## **MAGNOLIA SPRINGS SUBDIVISION, PHASE II**

APPLICATION NUMBER 12 DATE June 3, 2010

REQUEST Subdivision

# DETAIL SITE PLAN

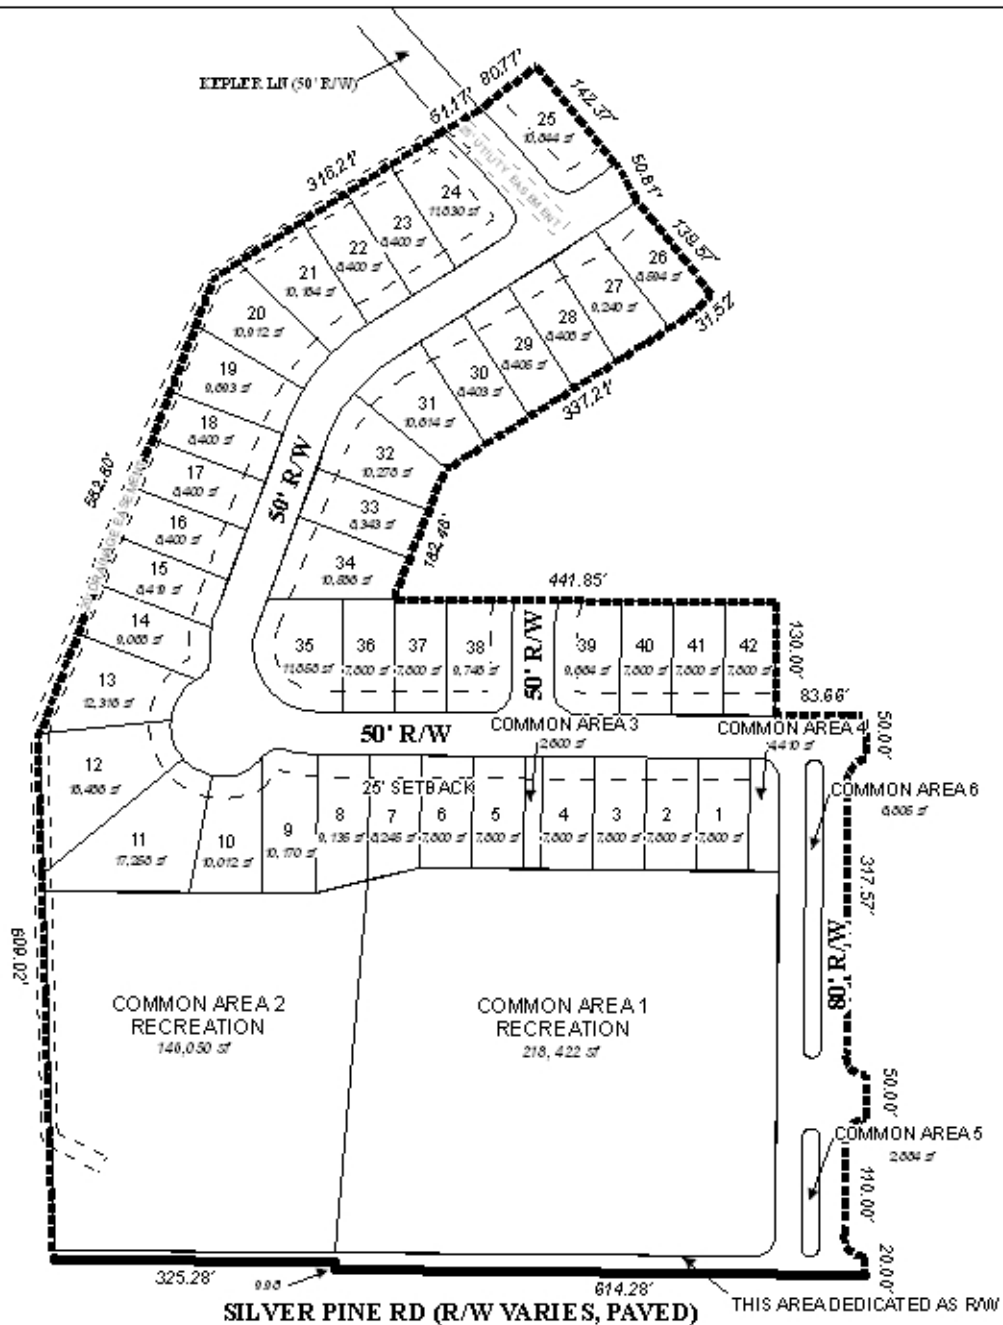
The plat illustrates the proposed 22.5± acre, 42-lot subdivision, which is located on the North side of Silver Pine Road at the North terminus of Maple Valley Road. The applicant states that the subdivision is served by public water and sanitary sewer.

There are several issues of concern with the proposed subdivision; first of all, a condition of approval for the overall 440 ± acre, 948 lot subdivision from the April 19, 2007 meeting of the Planning Commission was that each individual phase be submitted to the Planning Commission for review; however, this subdivision application expired in April of 2008. It should be noted that Phase One was approved as a separate application on November 21, 2008 and recorded in January of 2009: the approval of Phase One included a requirement for a Traffic Impact Study for the entire development with any future phase. It should be noted that the applicant did not submit a Traffic Impact Study with this phase of development; thus the study should be submitted with the new overall subdivision application. Secondly, all previous approvals have expired and no extensions have been filed; thus a new application for the overall development will need to be submitted. Thirdly, the proposed Phase Two seems to be deviating from the overall subdivision plan. Finally, the applicant has failed to comply with previous Planning Commission approvals.

- 1) composite subdivision application has expired, submission of a new overall subdivision application is required;
- 2) failure to comply with previous Planning Commission approval condition regarding the submission of a Traffic Impact Study; and
- 3) proposed Phase Two is deviating from the overall subdivision plan.
